Addendum No. 1
February 9, 2023

Project: Harrisburg Elementary School #8
Harrisburg, South Dakota
Architecture Incorporated Project #3000

Architect: Architecture Incorporated

HARRISBURG ELEMENTARY SCHOOL #8
EXTERIOR ELEVATION - AREA A

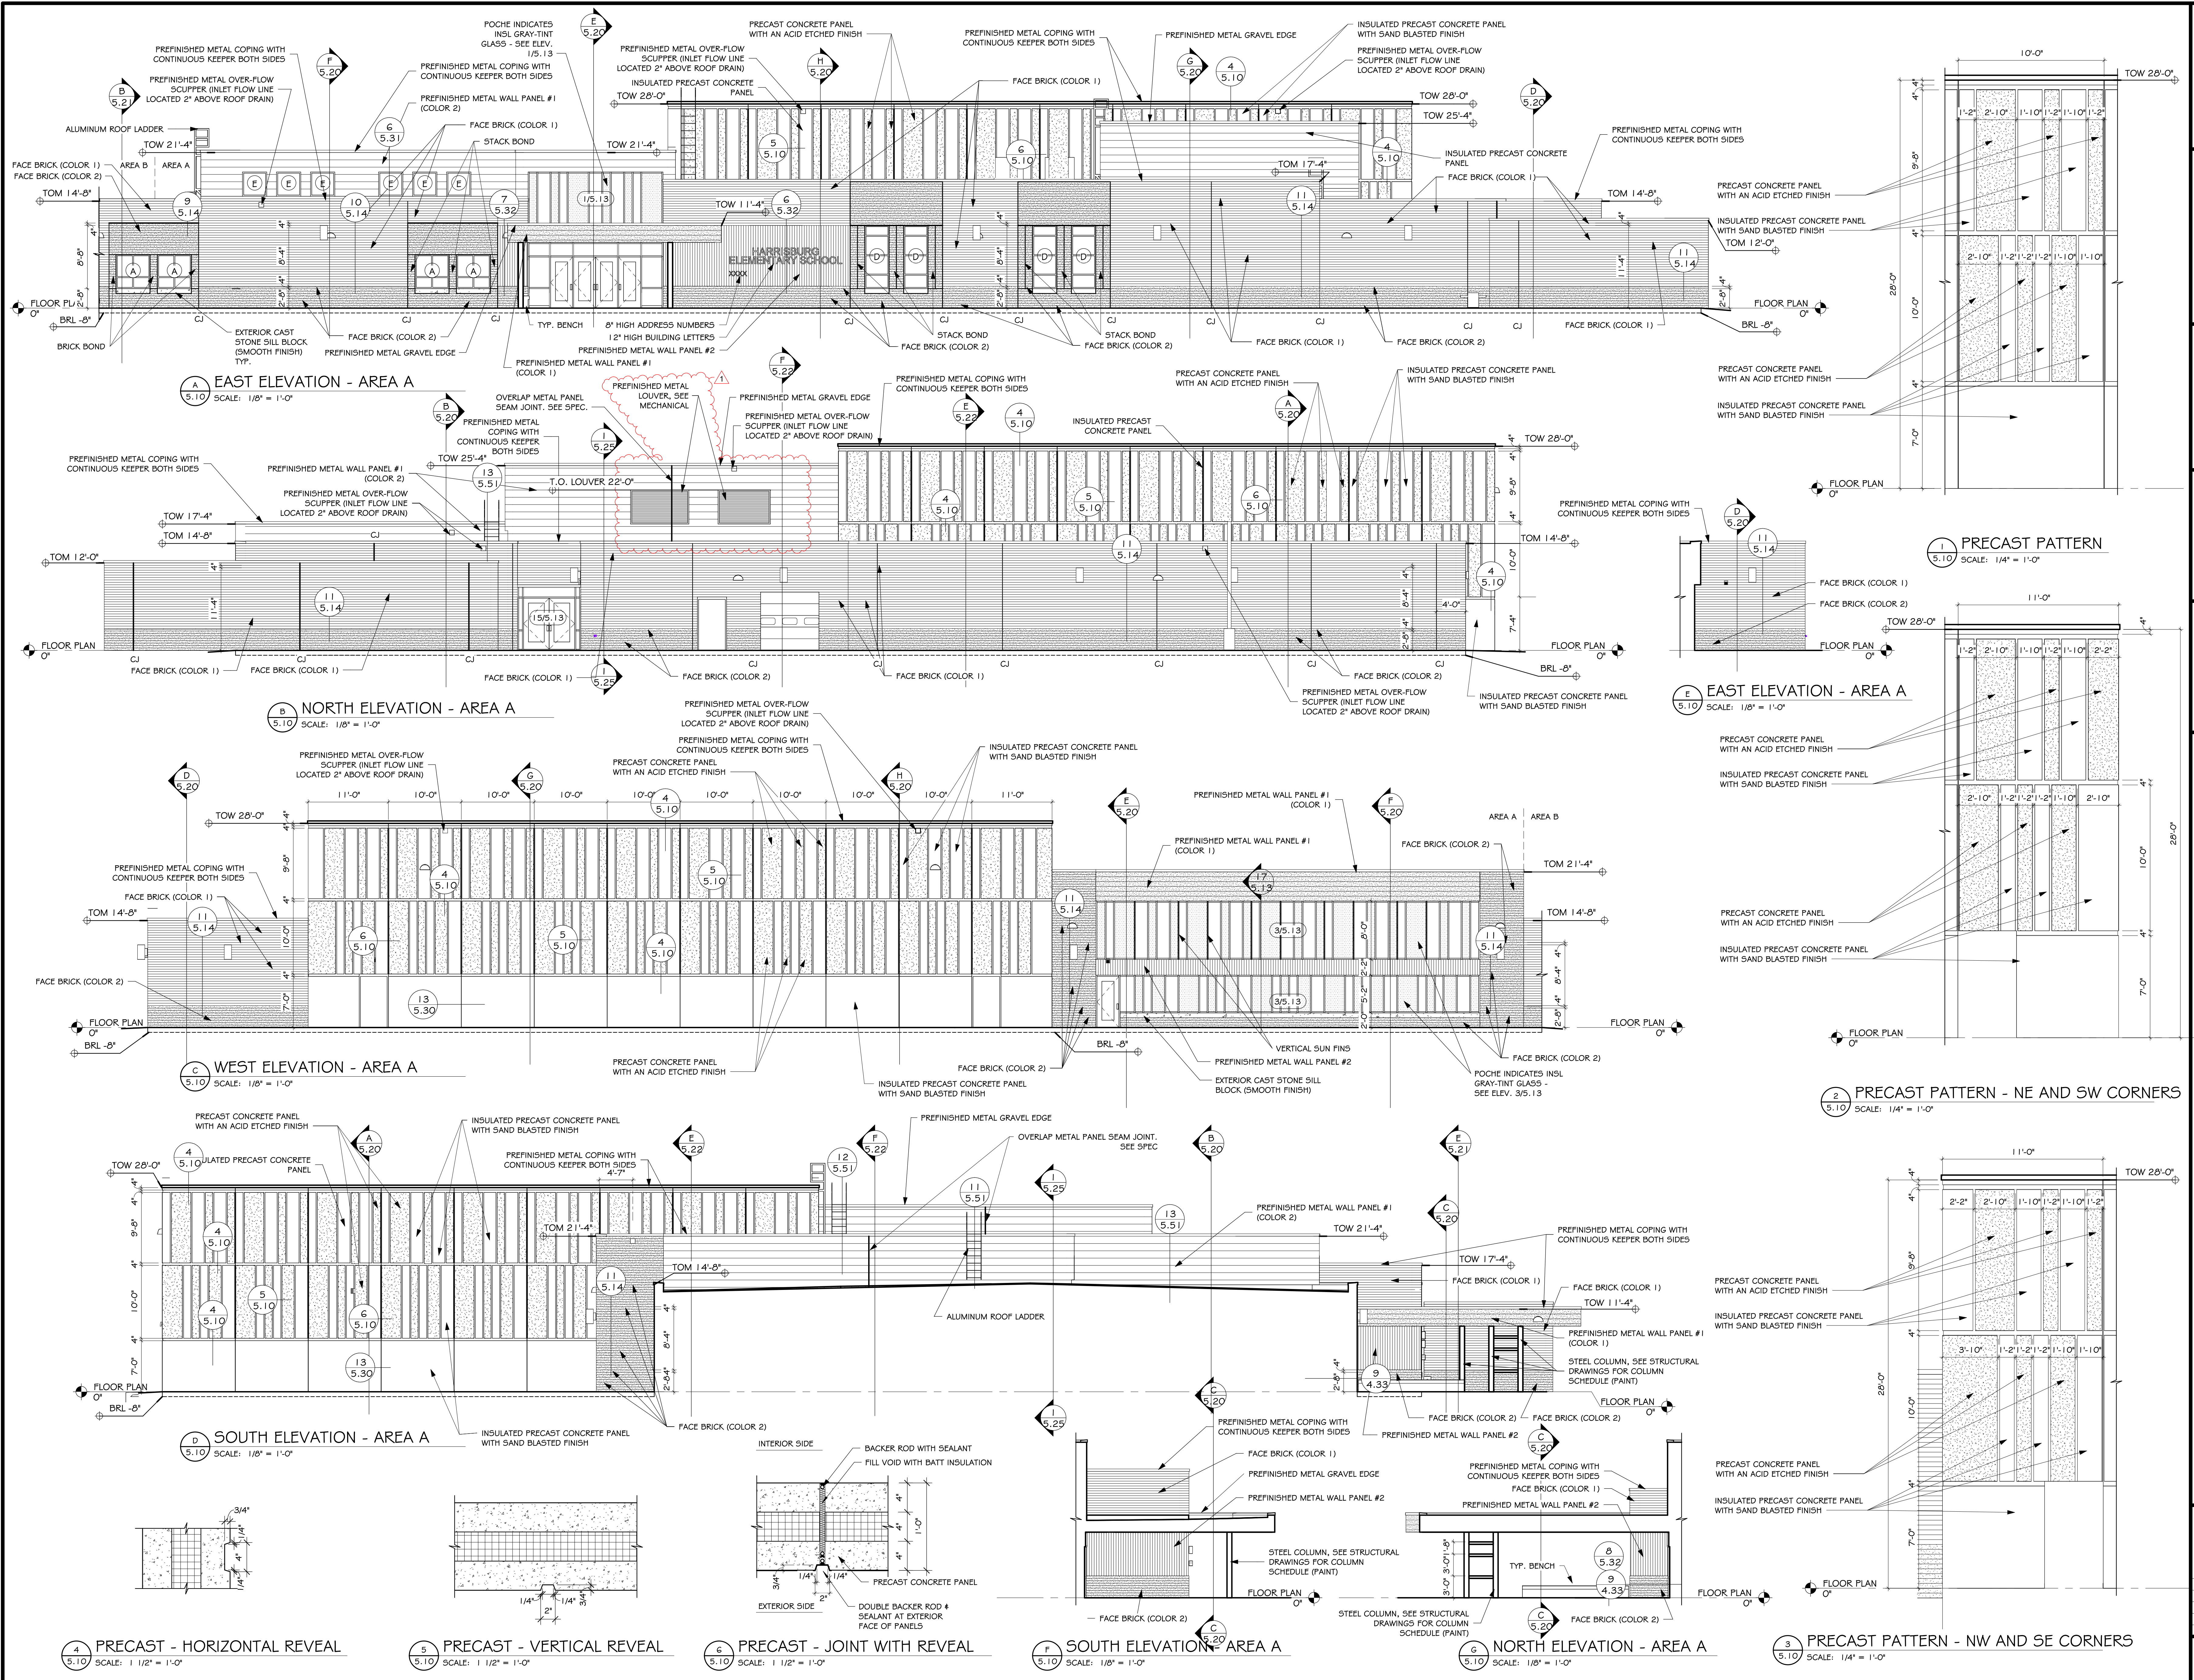
- a) Reference *B/5.10 North Elevation – AREA A* on the *revised* drawing Sheet 5.10, dated 2-9-23 for newly added prefinished metal louvers on the north wall of A200 PENTHOUSE; coordinate with mechanical for exact location and size of the louvers.
